GALLIEN-KRUEGER	PRODUCTION CHANGE ORDER	PCO#: 3
DATE: 7/23/91	ASSEMBLY #: 2060045 A	MODEL#: 800RB
ASSEMBLY DESCRIPTION: 800RB preamp board		PAGE 1 OF 3

ENGINEERING CHANGE ORDER

MODEL: 800RB

TITLE: **800RB ECO#26
REWIRE XLR JACK**

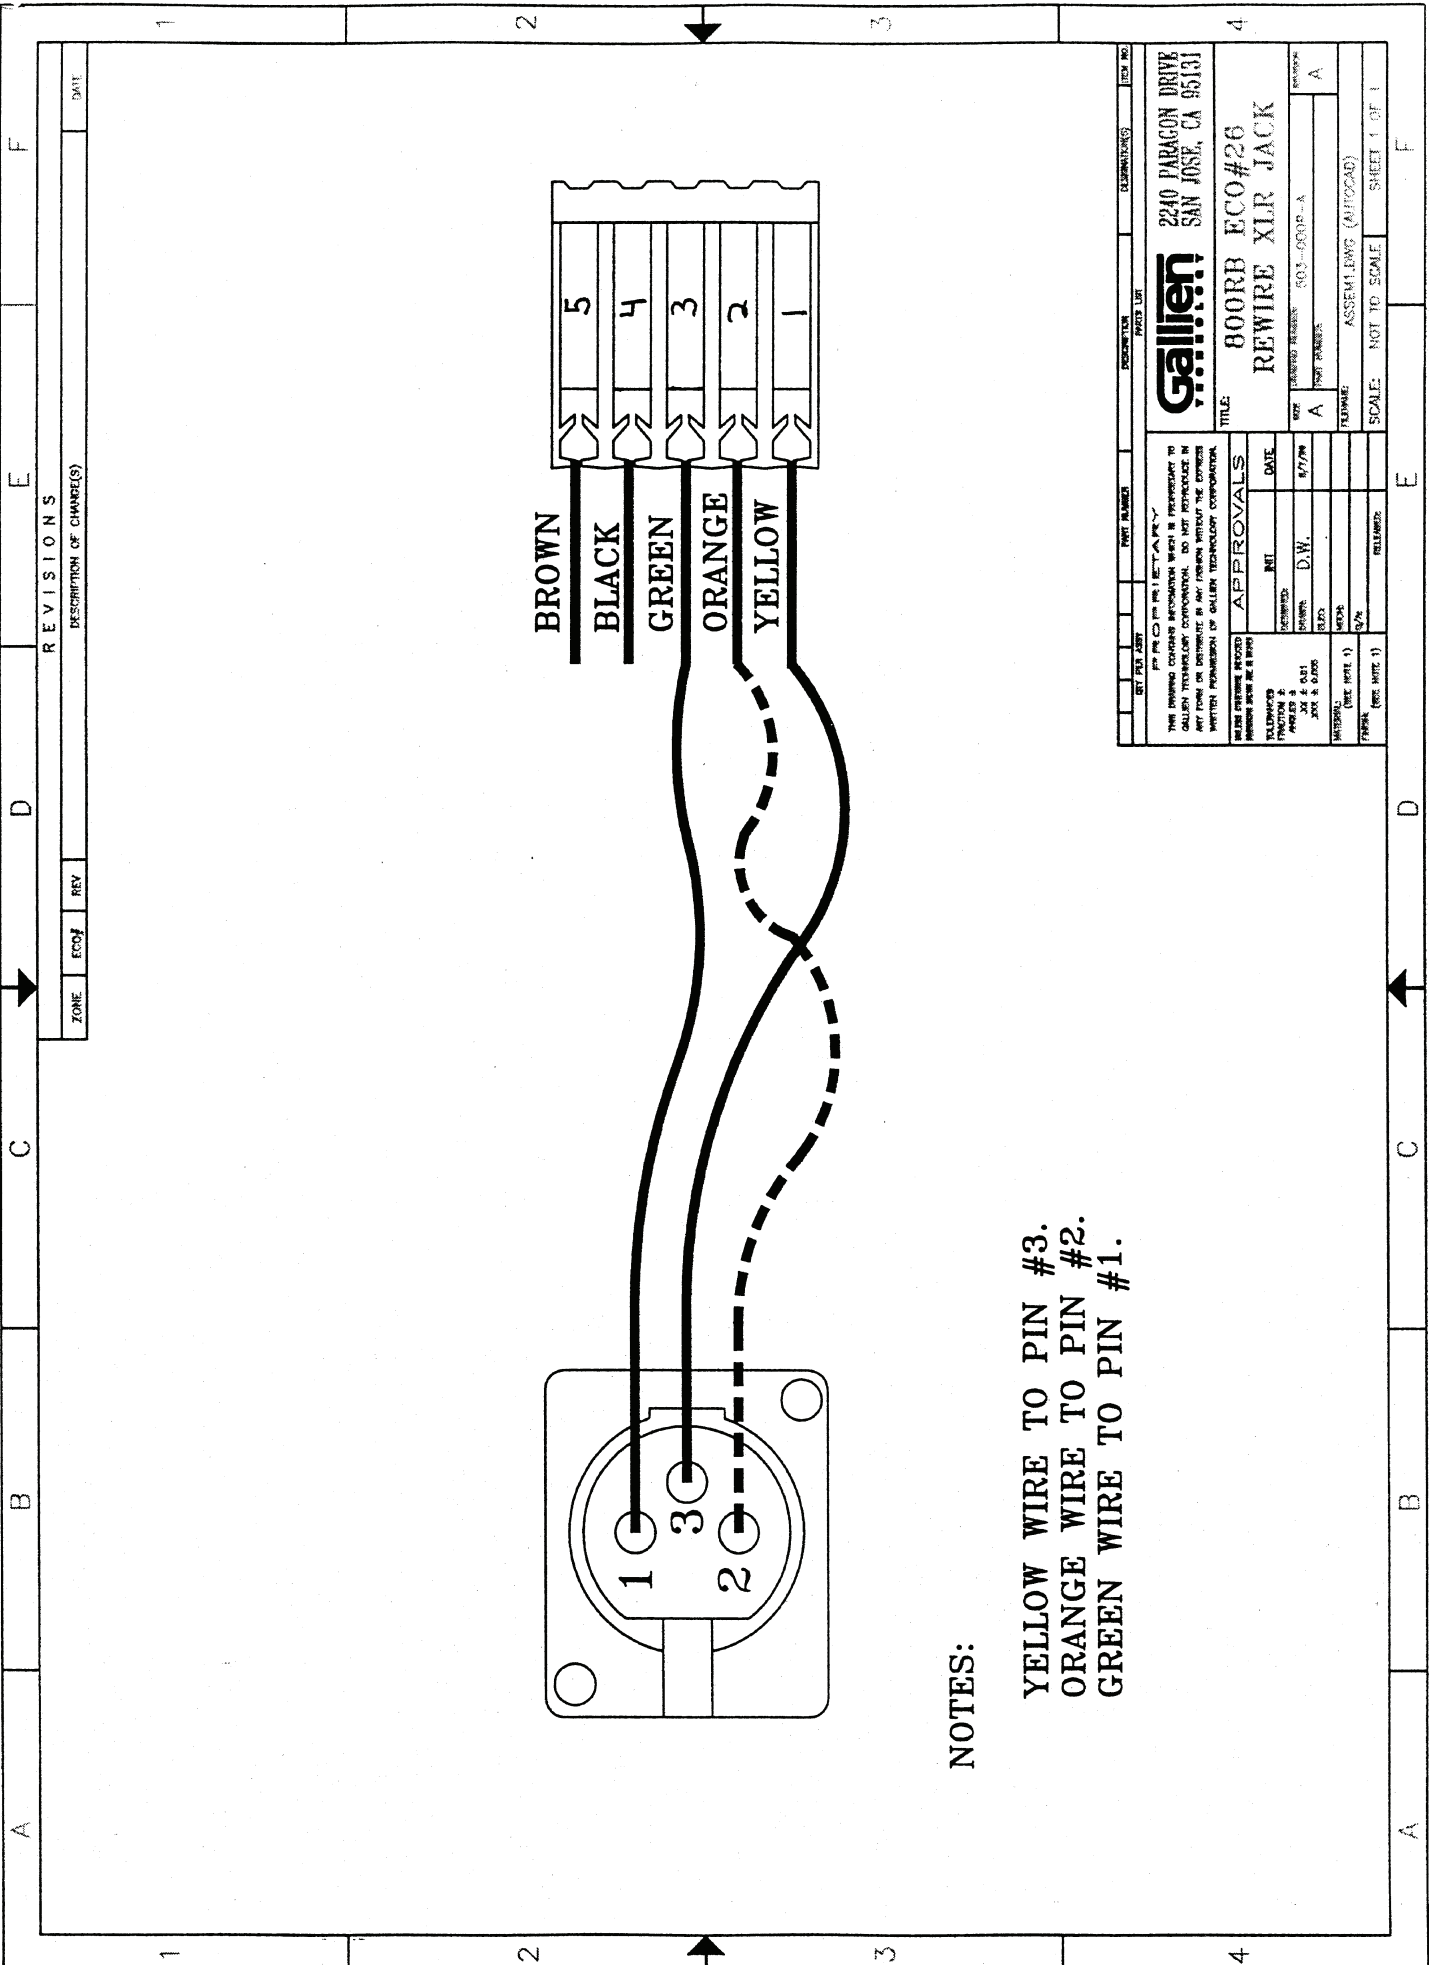
- YELLOW WIRE TO PIN #3.
- ORANGE WIRE TO PIN #2.
- GREEN WIRE TO PIN #1.
